SB001 – IC

Selective Call Intercom – Firmware v1.4 Unit Name Incompatibility with v1.3/v1.2

FIGURE 1

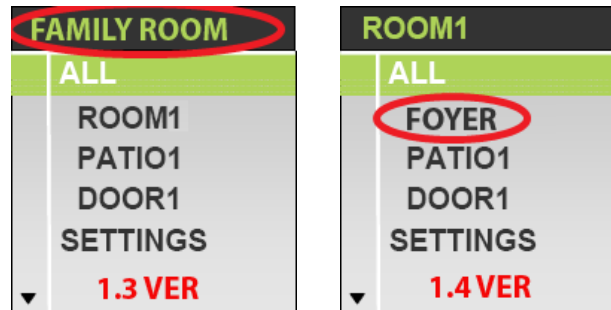
Once personalization of the system has begun and unique names have been chosen for each individual room by the installer, any names chosen after the letter “E” will appear differently across the various firmware revisions. The reason for this is that in adding “Exercise Room” to the list with version 1.4, the naming table in the firmware was shifted down by one. The v1.2/1.3 stations are subsequently not able to recognize the new name in the list or that the table itself has shifted.

Example: If you choose “Family Room” from the available names, all of the 1.2/1.3 units will show the correct name while the 1.4 units on the system would now show “Foyer” for that same room due to the shift in the naming table (see Figure 3). Any names chosen before the letter “E” will appear properly as they are not affected by the naming incompatibility.

The best remedy to this issue is to have the firmware updated for all units on the system to version 1.4. If you are experiencing this naming incompatibility, please contact Technical Support at 1-800-321-2343, Option 1. Technical Support will work with you to provide a firmware update to correct the problem.
